Access Compliance Report Public Rights-of-Way (Curb Ramps)

Main Street: N_MUSTANG_AVE Cross Street: RANDALL_ST Location: NE

ADA ID: RPRK211222113303 Ramp Type: Type 4 - Parallel Initial Pass/Fail: Fail Overall Compliance: No Severity Score: 16

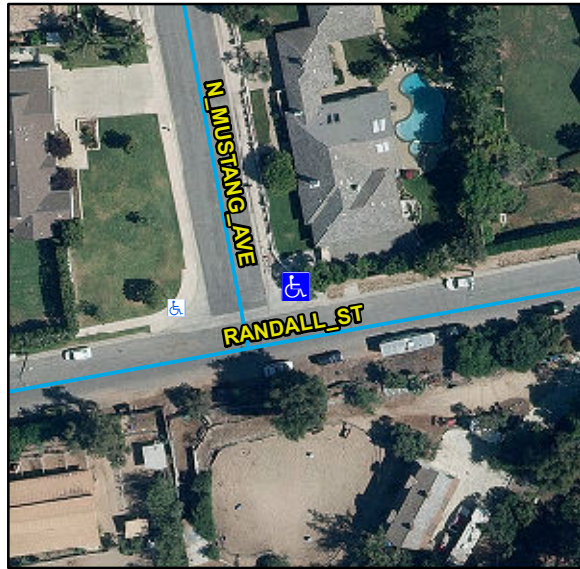
Compliance	Description	Data	Compliance	Description	Data
N/A	Ramp Length LT (in)	98	N/A	Ramp Length RT (in)	152
Yes	Ramp Width LT (in)	100	Yes	Ramp Width RT (in)	100
Yes	Ramp Run Slope LT (%)	0.8	No	Ramp Run Slope RT (%)	9.4
No	Ramp Cross Slope LT (%)	5	No	Ramp Cross Slope RT (%)	3.3
N/A	Landing Present	N/A	N/A	DWS Provided	N/A
N/A	Landing Length (in)	N/A	N/A	DWS Contrast	N/A
N/A	Landing Width (in)	N/A	N/A	DWS Length (in)	N/A
N/A	Landing Run Slope (%)	N/A	N/A	DWS Full Width	N/A
N/A	Landing Cross Slope (%)	N/A		DWS Offset Type	N/A
N/A	Landing Movement Obstructed?	N/A	N/A	DWS Offset Left (in)	N/A
	Landing Movement Type	N/A	N/A	DWS Offset Right (in)	N/A
N/A	Landing Shared	N/A			
N/A	Clear Space	Yes			
N/A	Clear Space To Crosswalk (in)	N/A			
N/A	Marked Crosswalk 1	No	N/A	Marked Crosswalk 2	No
	Crossing 1 Direction	W		Crossing 2 Direction	S
	Marked Crosswalk 1 Width (in)	N/A		Marked Crosswalk 2 Width (in)	N/A
N/A	Ramp Inside Crosswalk 1	N/A	N/A	Ramp Inside Crosswalk 2	N/A

Remove & Replace Curb Ramp With Two New Directional Ramps or Equivalent.
